CITY OF HOOD RIVER

To: Mayor and City Council

From: Planning Commission

Re: Recommendations for Westside Area Concept Plan Frameworks (File No. 2018-07)

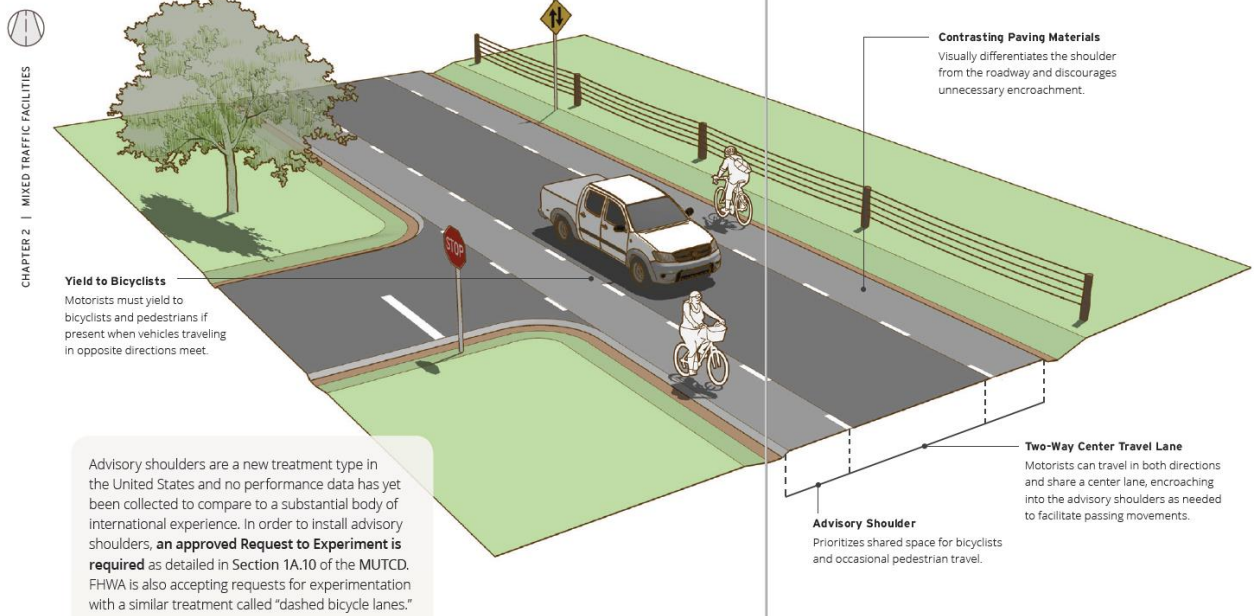
- Revise the proposed Minor Arterial cross-sections (specifically "Alignment D" of the "Mt. Adams extension") to replace on-street buffered bike lanes with physically separated bike lane as depicted in the Federal Highway Administration's "Small Town and Rural Multimodal Networks" publication

(see image below). However, also consider maintenance requirements for physically separated bike lanes. The separated bike lane design is intended to better accommodate novice and younger cyclists, and it provides an additional buffer between vehicles and pedestrians. As depicted in the following image, the bicycle path returns the cyclists back to the road at intersection locations.

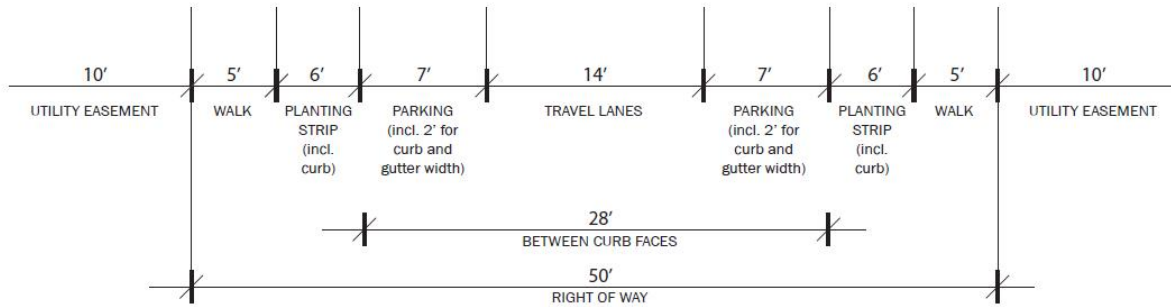
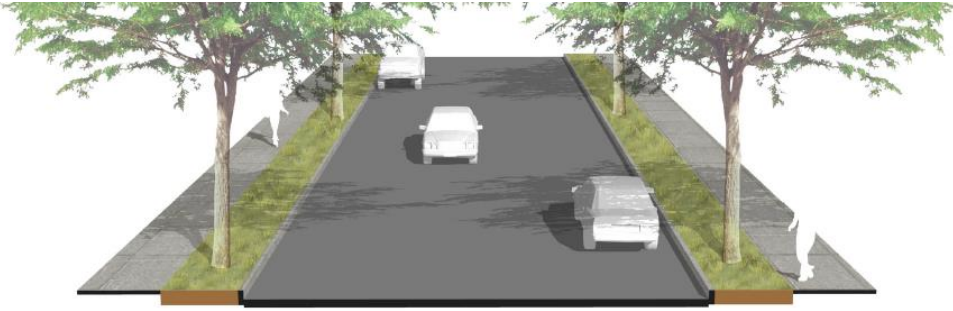
- Revise the proposed “Neighborhood Connector” cross section to incorporate “advisory shoulders” where on-street bicycling shares space but is visibly separated from two-way, alternating, vehicle passing movements (see concept below). The cross section should include physically separated sidewalks that are a minimum of 6 feet in width wherever possible. The suggested half-street cross section includes a 6-foot-wide sidewalk, 7-foot-wide planter strip, 7-foot-wide on-street parking, 4-foot-wide bike lane, all used in combination with a single 12-foot-wide vehicle travel lane that accommodates two-way traffic.

Neighborhood Traffic Management Tools

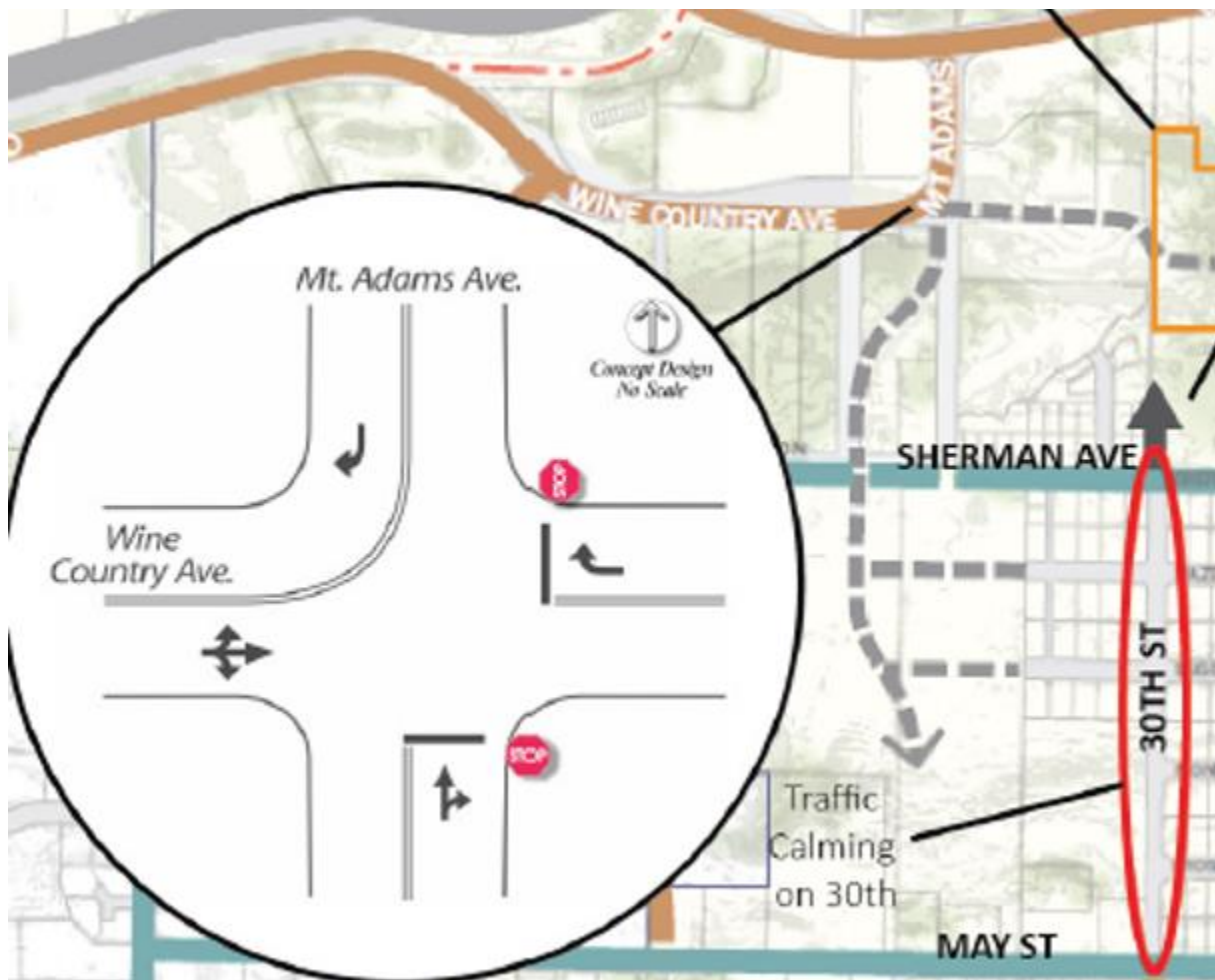
- The Commission supports incorporating traffic calming measures on 30th Street north of May Street to slow and limit cut-through traffic by using specific design features identified in the Concept Plan Report (see examples below). The specific methods and locations of traffic calming measures should be determined by the City Engineer as needed.

“Westside Community Trail”:

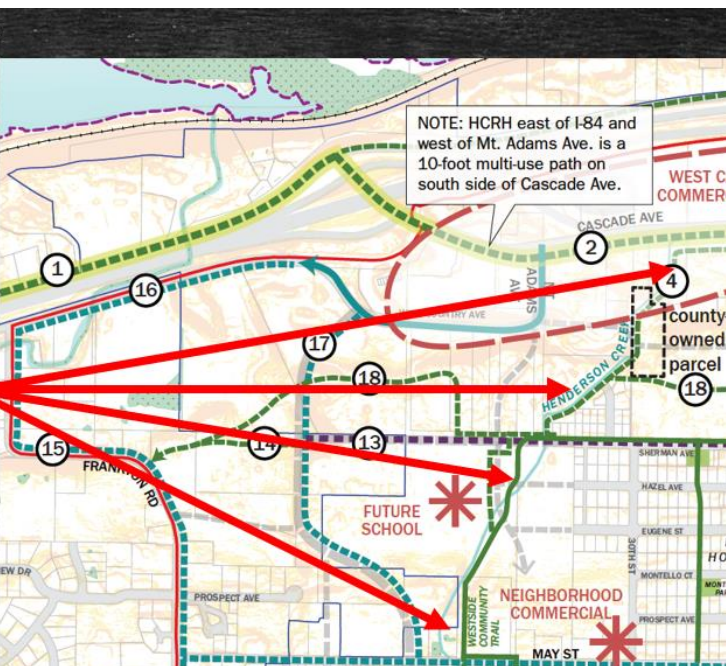
- Along Rocky Rd., pedestrians should not be on street.
- Retain existing segment immediately north of May St.

- Avoid use of streets/sidewalks for portions of off-road trails (e.g. where Henderson Creek Trail crosses Sherman Ave.) but, if necessary and if constructed as a multi-use path, add seamless protected bike lanes where paralleling street.
- An off-street pedestrian connection is not needed along a Neighborhood Connector street on the school district’s property south of Sherman Ave. and west of Henderson Creek Trail.
- Ensure east/west pedestrian connections on Hazel Ave. and Eugene St. between Fox Hollow subdivision and school district’s property.
- Provide a connection between the Mt. Adams extension (i.e. “Alignment D”) and the Henderson Creek Trail along north side of May St.

"Ridgeline Trail":

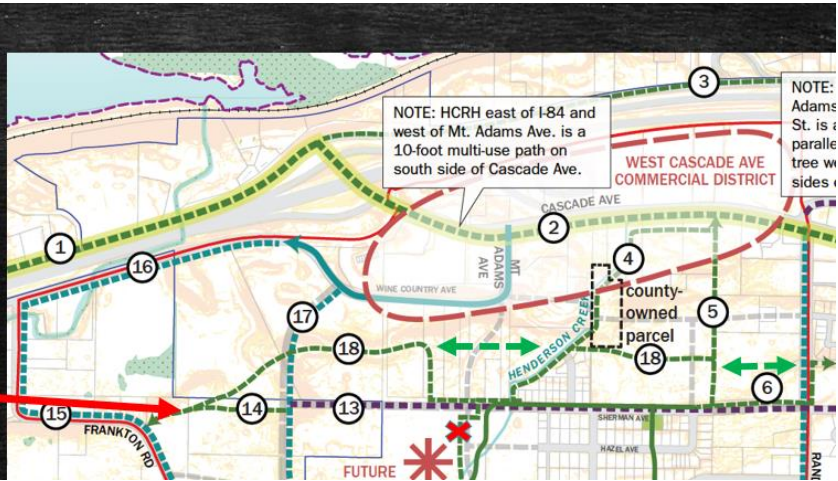
- Support new trail
- Minimize segments relying on sidewalks with bikes on street (avoid if possible).
- Refinement of location needed near Frankton Rd.

"Westside Community Trail":

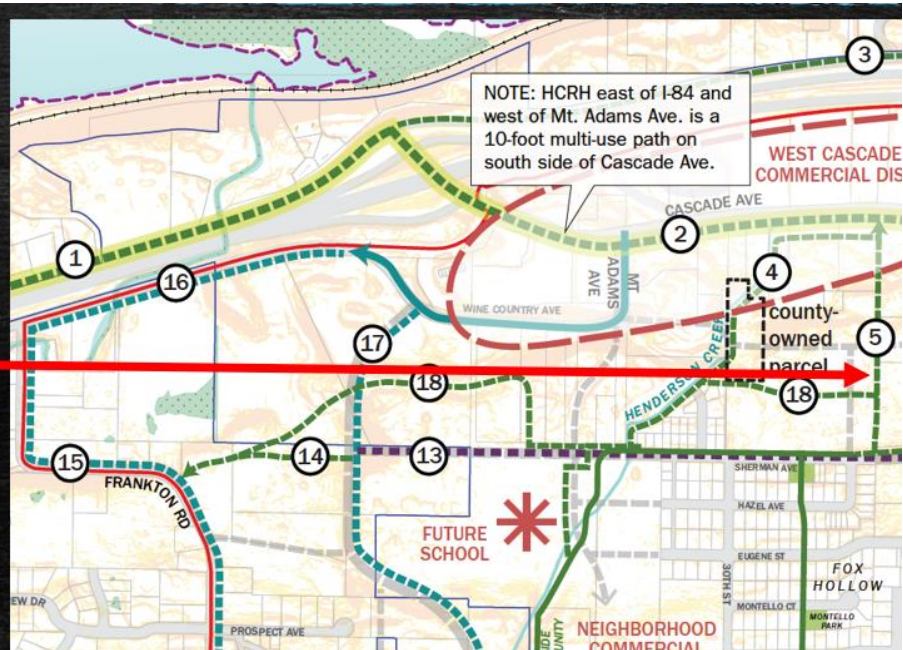
- Trail Segment 12 off of Frankton Rd. should be via Carr Drive rather than Blackberry Dr., through Willow Ponds to Rocky Rd.

Figure 4-1. Shared Use Path Dimensions

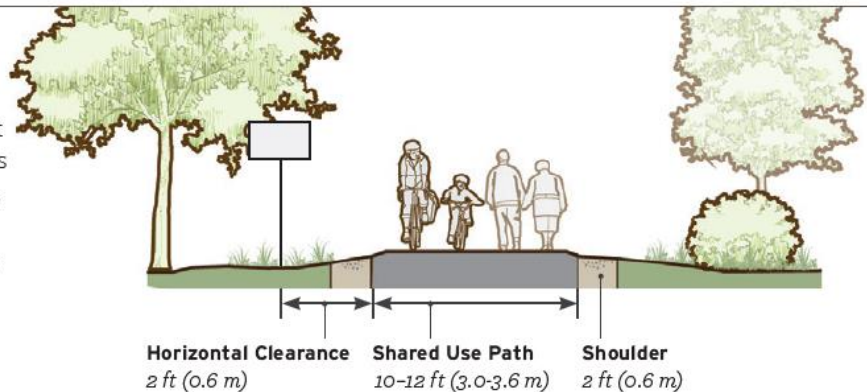
- Provide greater detail in the TSP about the intended treatment of bicycle boulevards and “Neighborways.”
- Develop a cross section for a high traffic/speed multi-use path along Henderson Creek that features dedicated lanes for two-way bicycle and pedestrian users such as may be found in the Netherlands, including design details for intersections of such paths with streets. The CROW Design Manual for Bicycle Traffic is considered the main guide to Dutch bikeway engineering, and the US equivalent is the NACTO (National Association of City Transportation Officials) Urban Bikeway Design Guide. The American Association of State Highway and Transportation Officials (AASHTO) published a Guide for the Development of Bicycle Facilities (4th Ed., 2012) that includes design recommendations for shared-use
